CITY OF HARTFORD, CONNECTICUT
DEPARTMENT OF PUBLIC WORKS
BUREAU OF ENGINEERING SERVICES

REVISIONS TO PARK RIVER
CONNECTIONS & MANHOLES
AT MAIN STREET

SOUTH CONNECTION & ACCESS MANHOLE

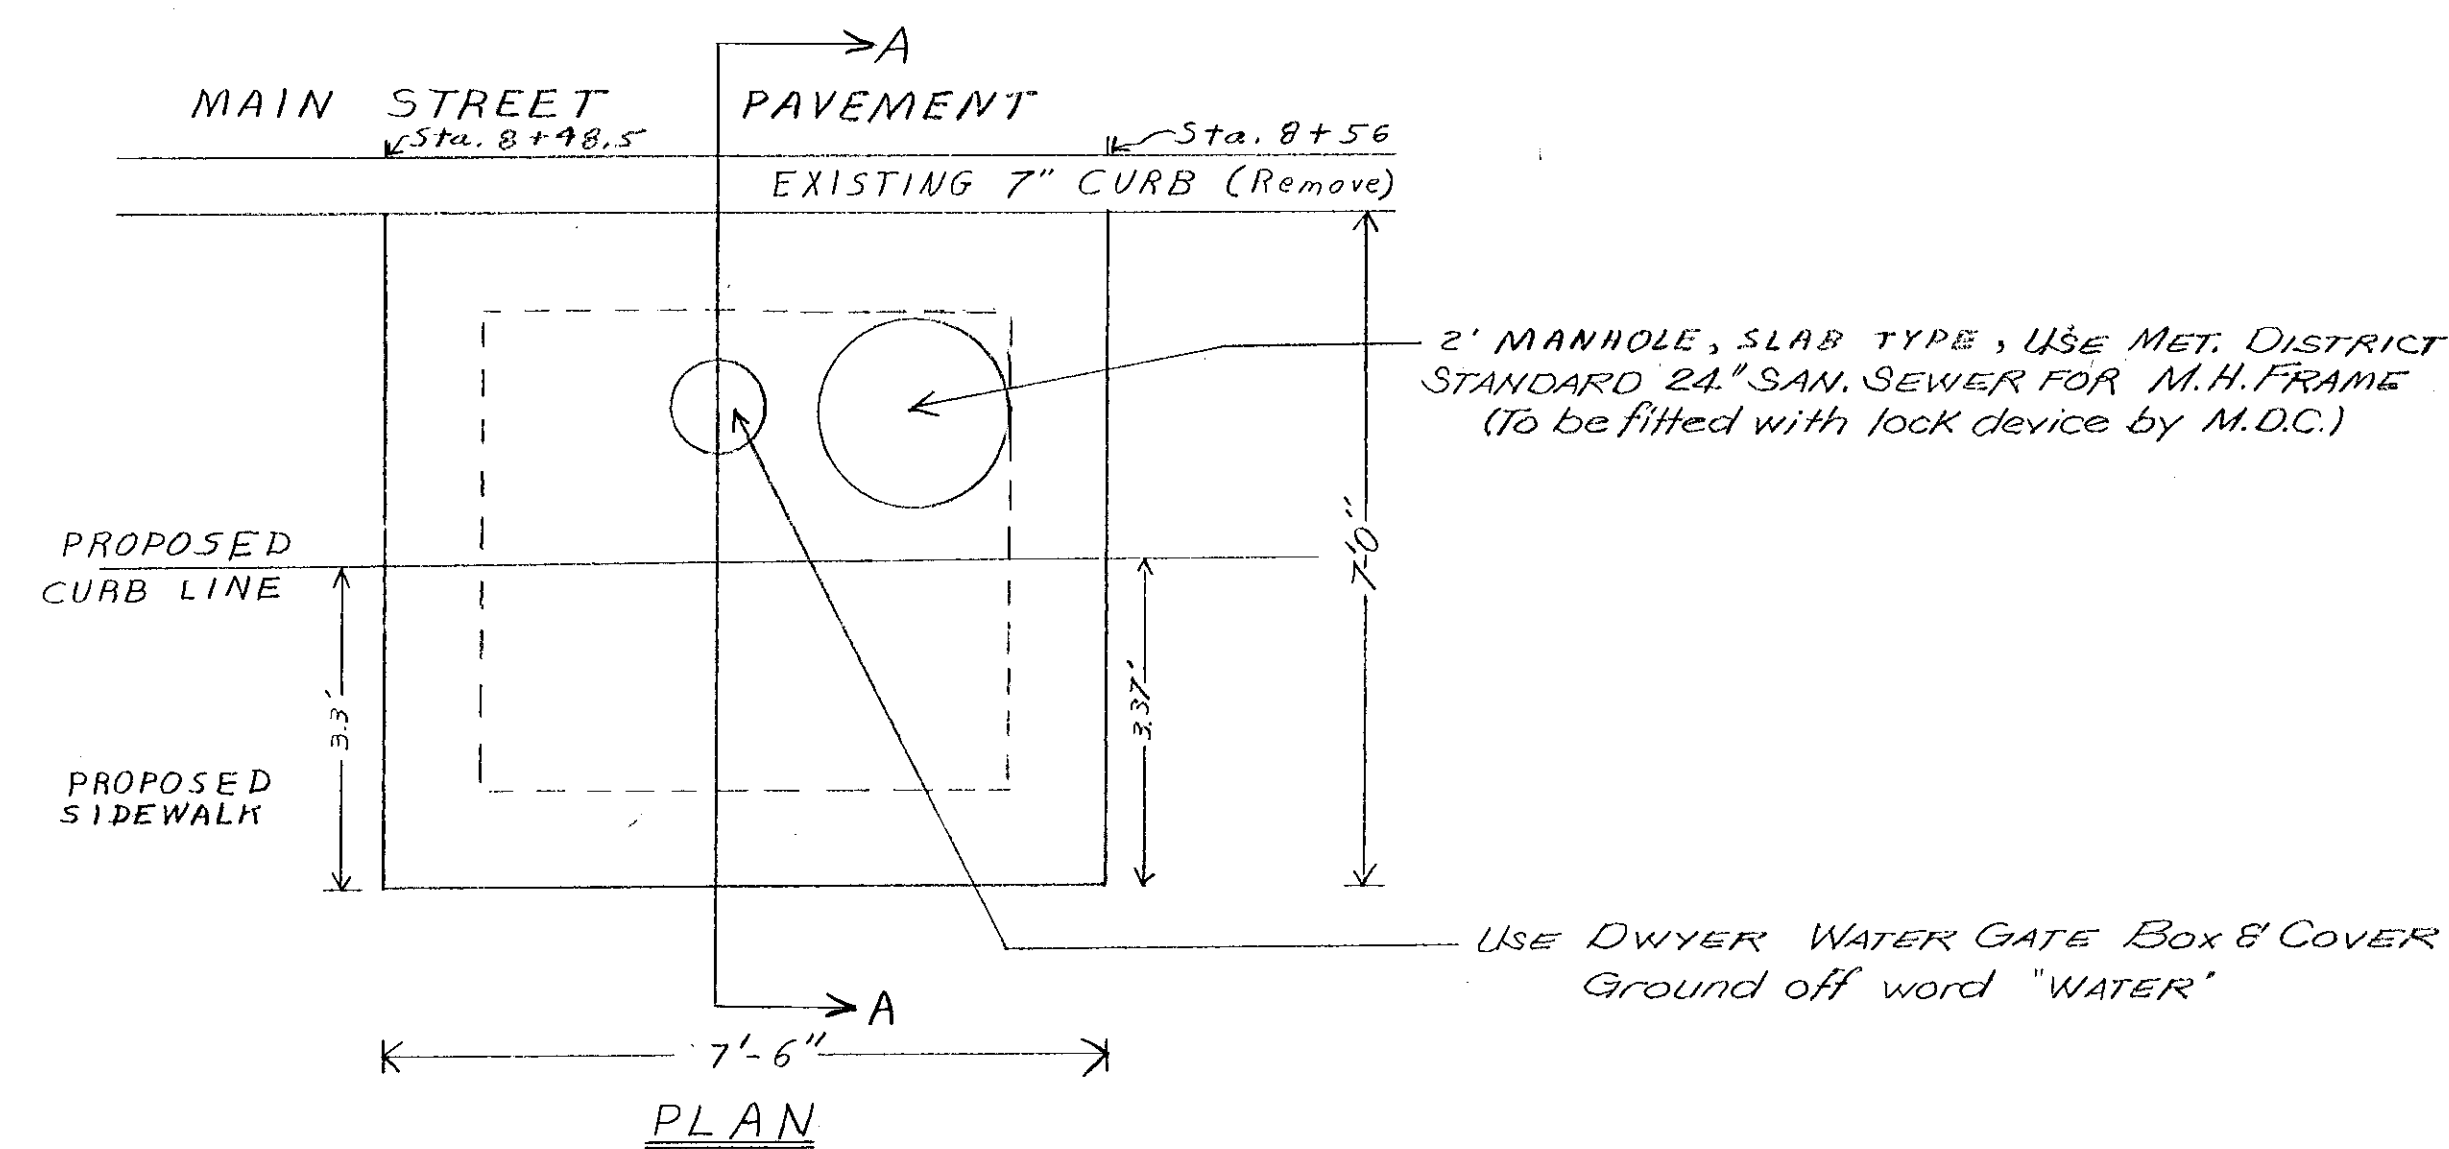
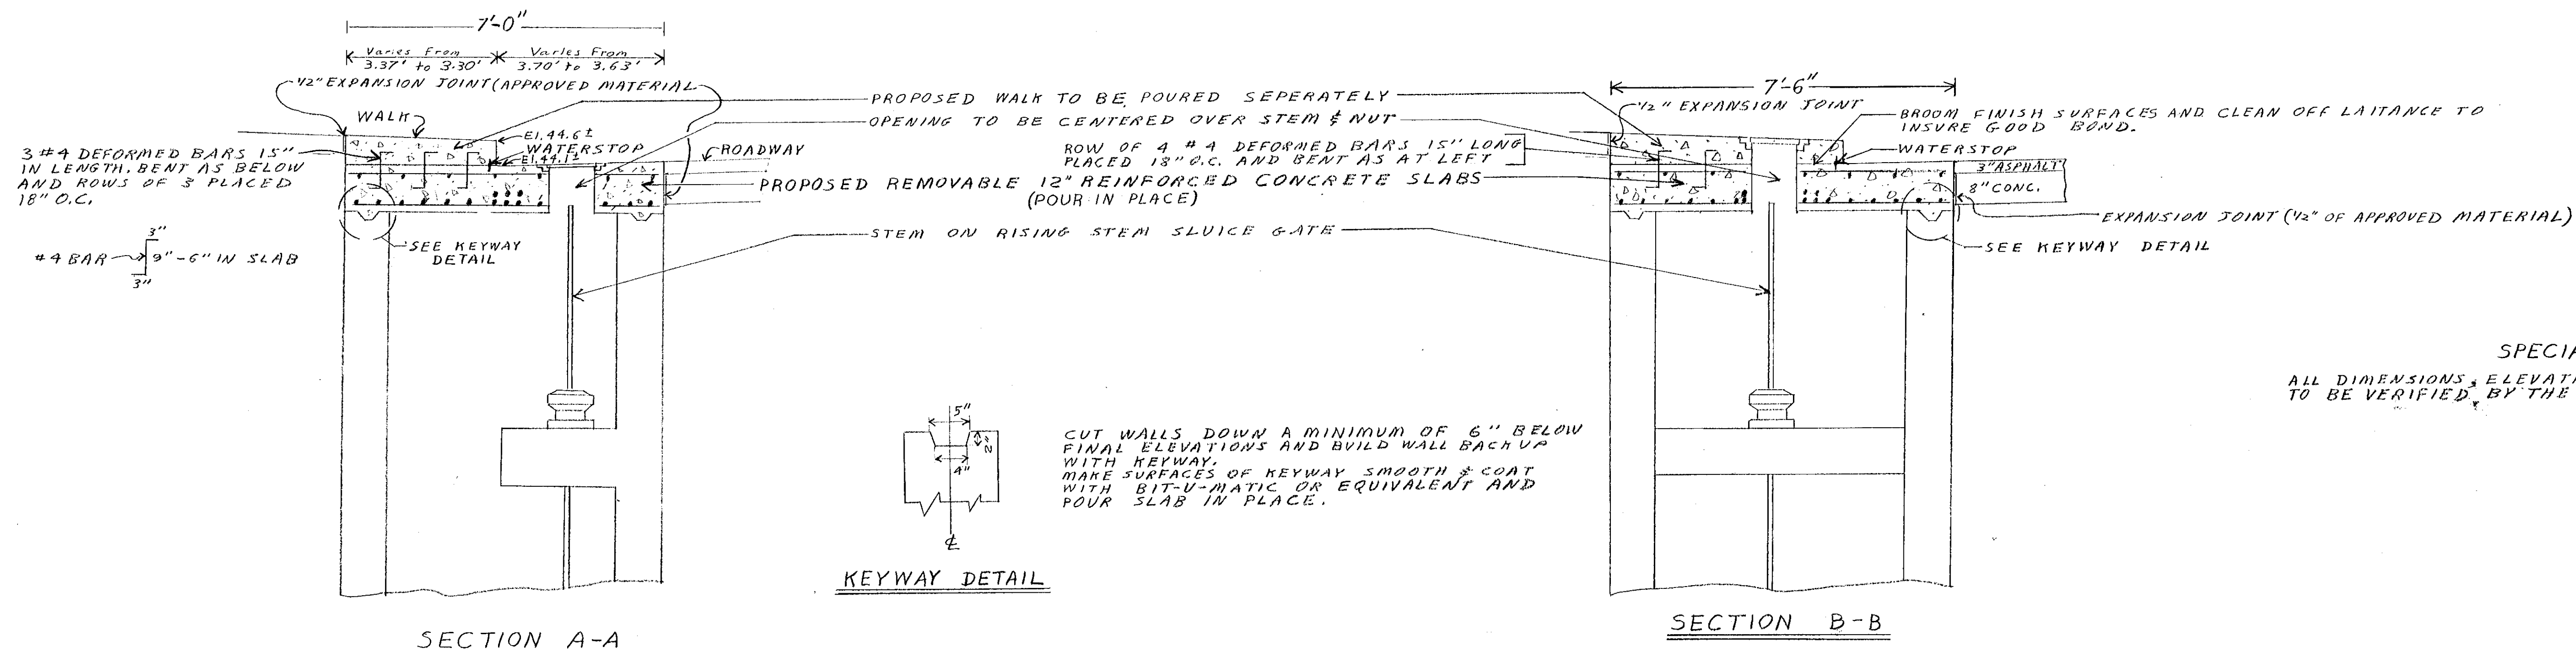
STATION 8+48.5 to 8+56

NORTH CONNECTION & ACCESS MANHOLE

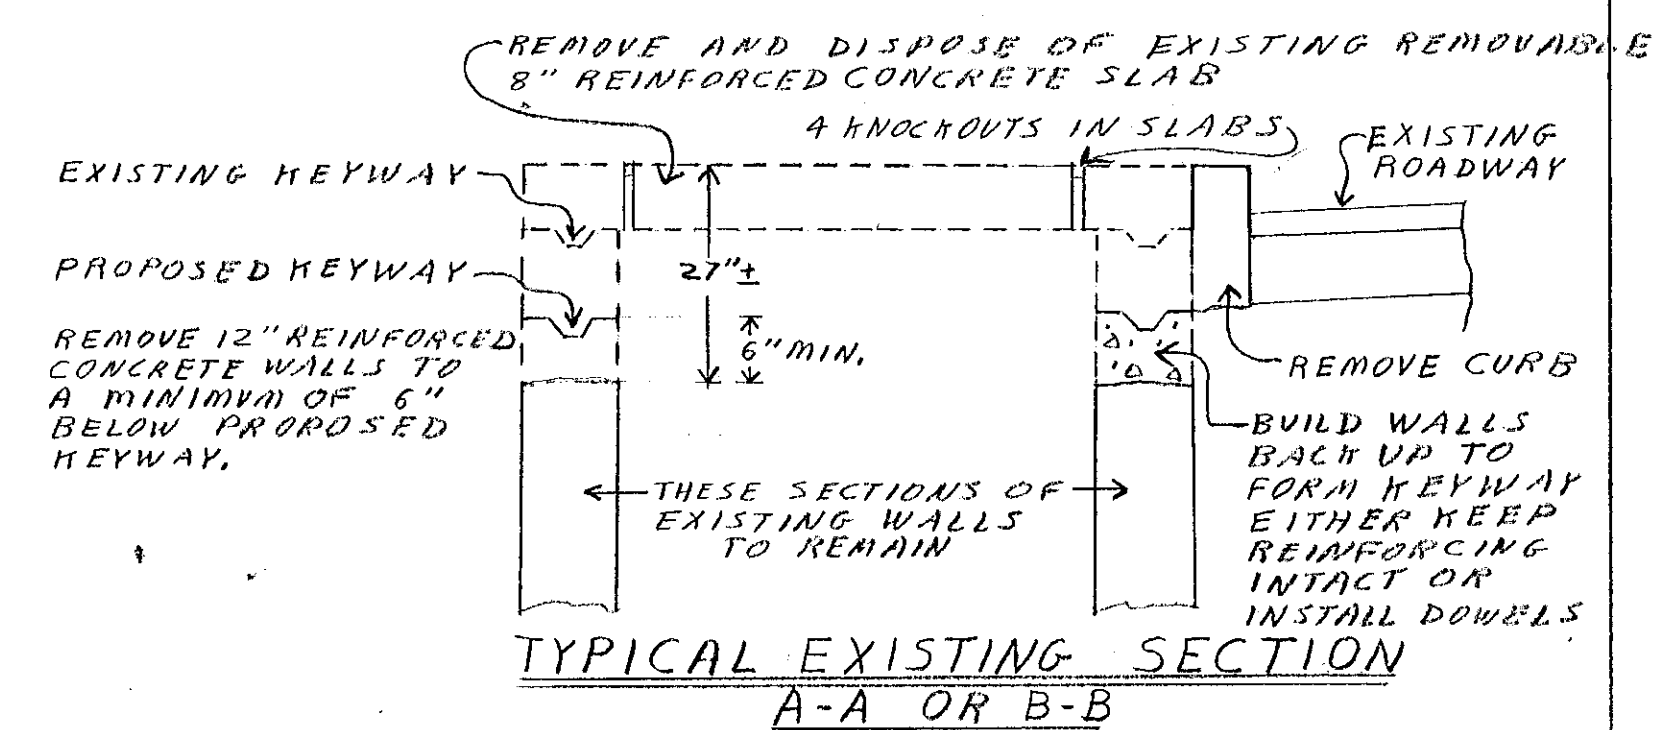
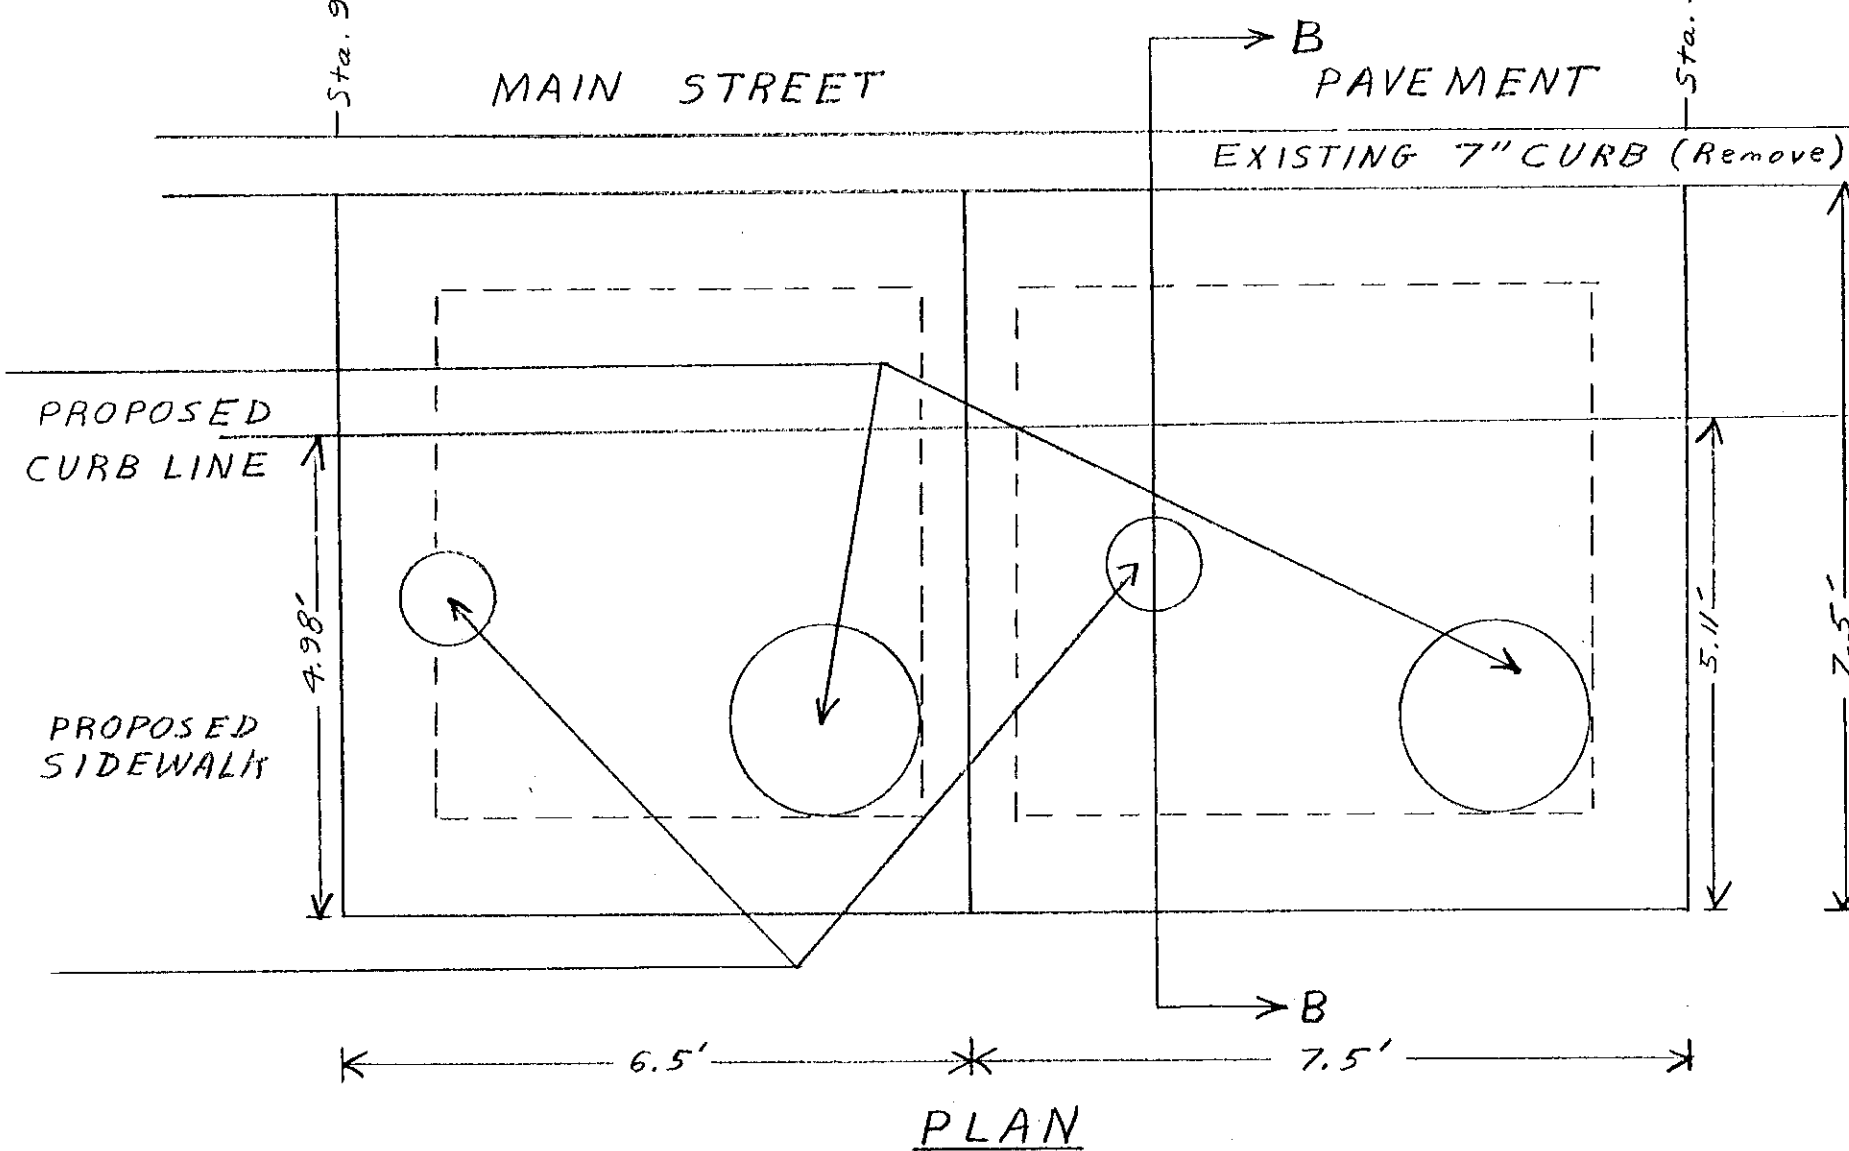
STATION 9+71 to 9+85

REINFORCING

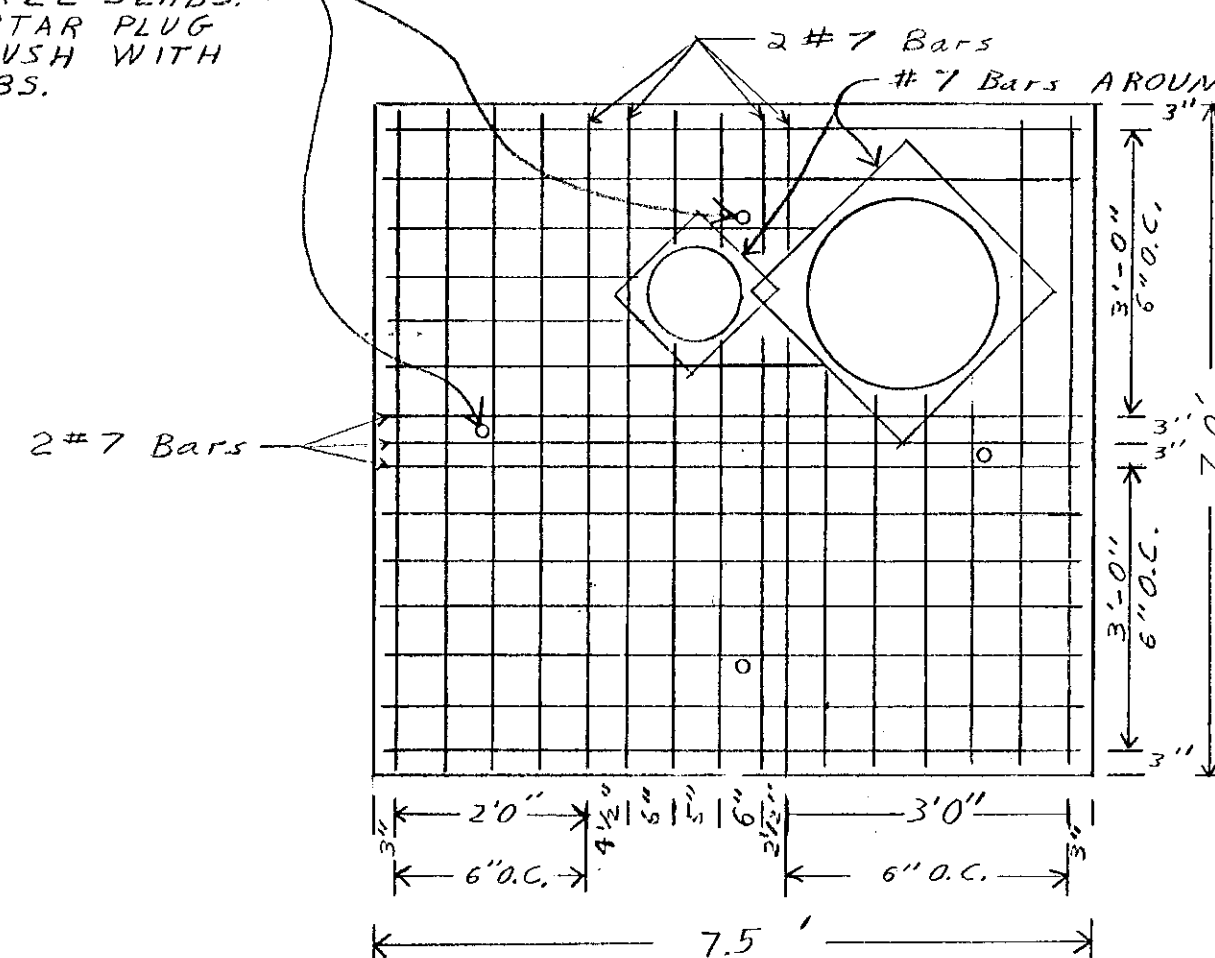
INSTALL 4-1/4\"/>

REINFORCING SHOWN IS THE BOTTOM REINFORCING #7 Bars 6\"/>

REINFORCING

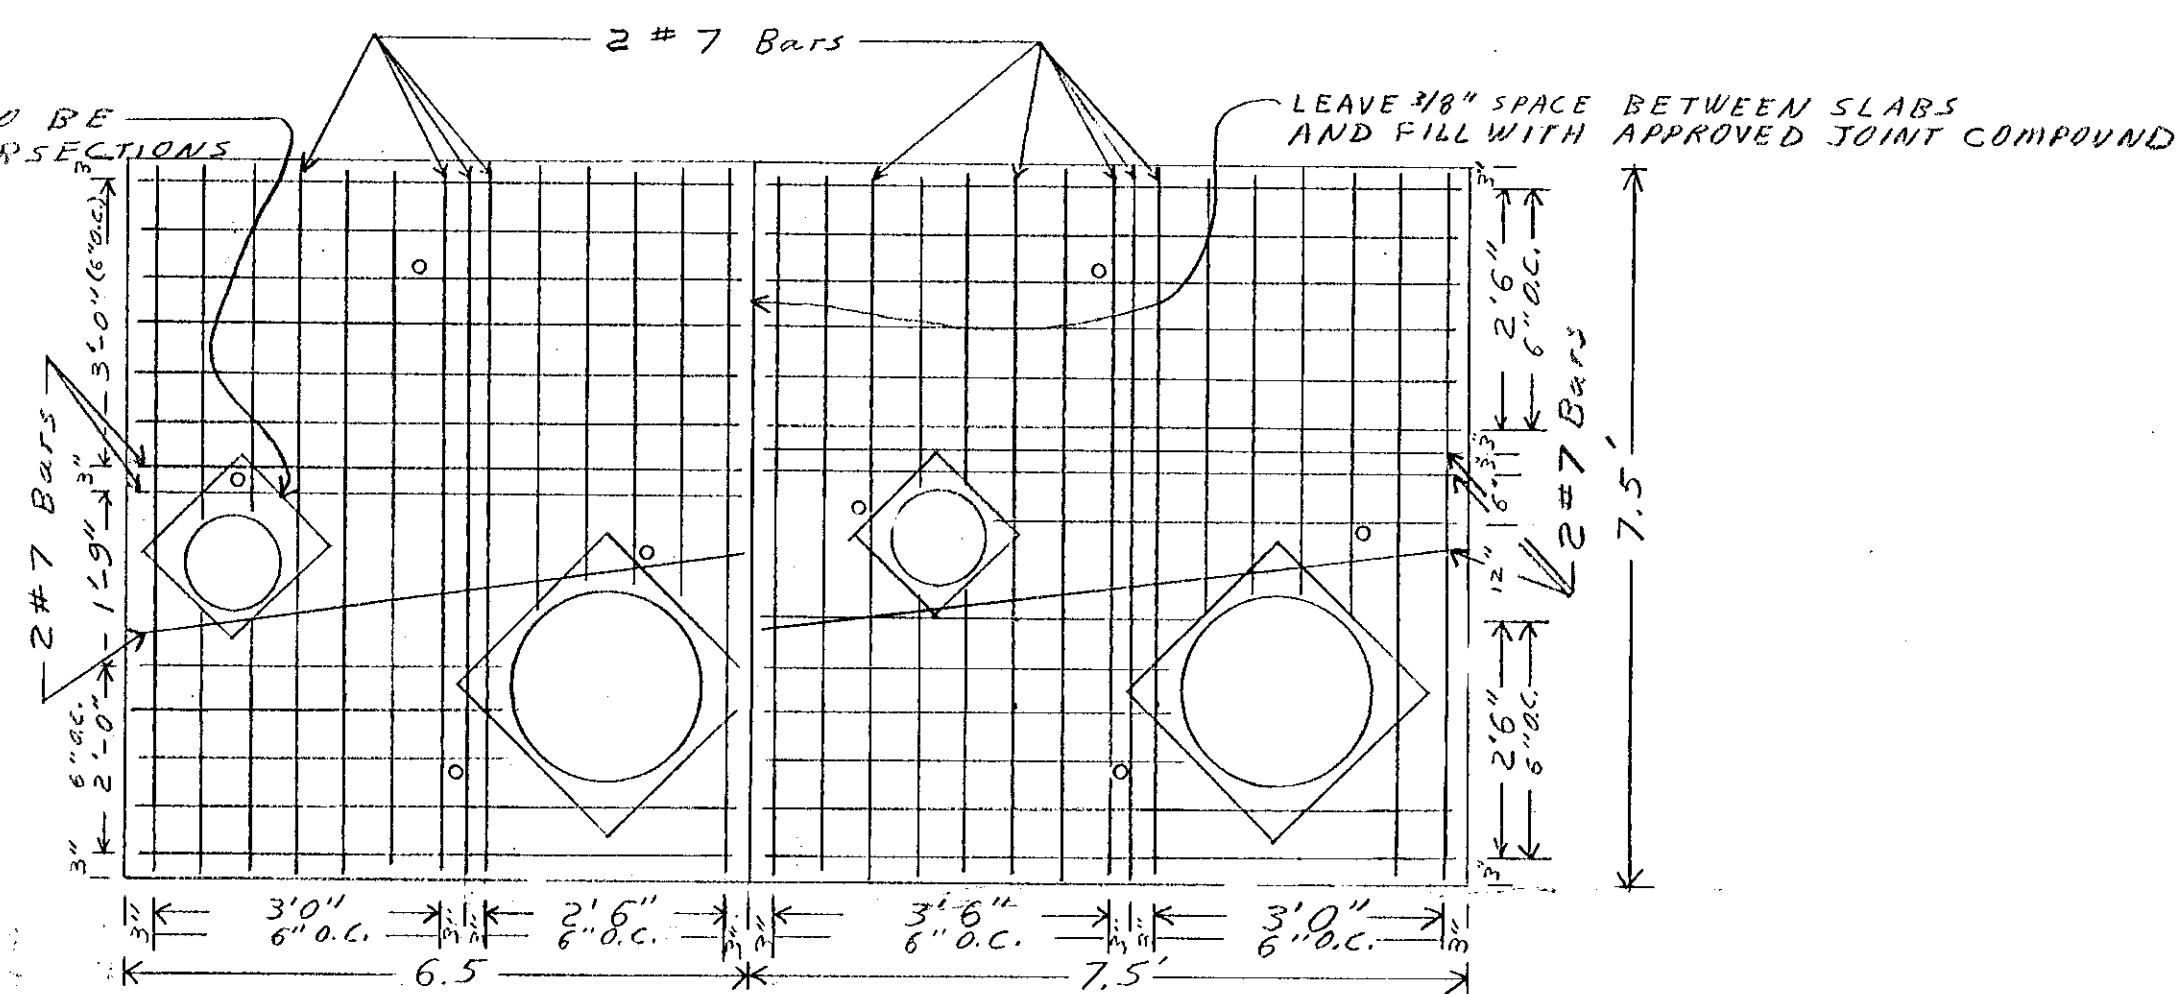
TOP REINFORCING IS TO CONSIST OF #4 Bars 12\"/>
